**Response to Council RFI – Stormwater/Civil Items
for 40 Myoora Road, Terrey Hills NSW 2084**

We refer to council's Request for Additional Information about Application (DA2024/1362), in particular the stormwater/civil comments. We would like to comment and provide responses to the issues raised specifically in the DA consent condition below:

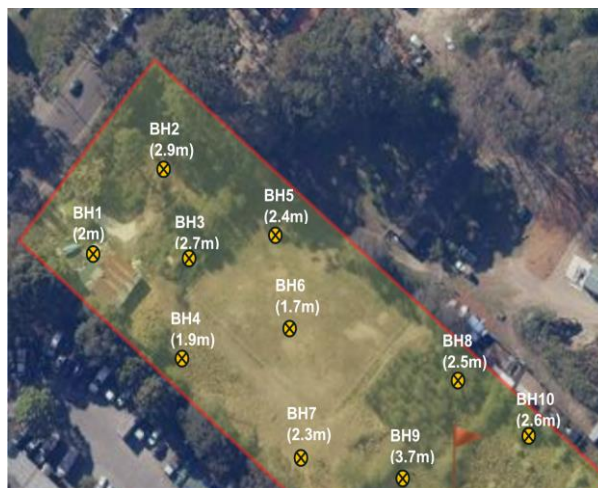
1. According to Council's records, a Council's stormwater lintel pit connects to a 1350mm Council's channel chamber travelling across the road. Please discharge stormwater runoff from the subject site to this kerb inlet pit which will resolve the surcharge issue from the boundary pit. An indicative location of Council's drainage infrastructures is attached at the end of this referral letter.
The outlet of the proposed OSD Tank has been updated to connect to the abovementioned 1350MM Council stormwater channel in Myoora Road. See latest Civil Drawings for more details
